SERVICE BULLETIN

M1274

Tool Kit Running Change

Figure 1. Service Supplement Page

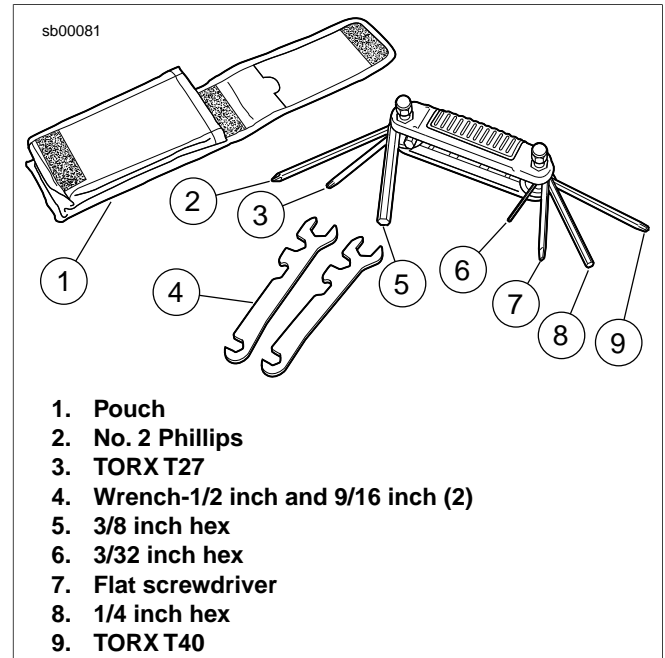
See Figure 1. Update appropriate literature and notify the parts and service personnel of running change from Tool Kit (Part No. 94435-02B) to Tool Kit (Part No. 94435-10).

There are no carryover parts in the new tool kit.
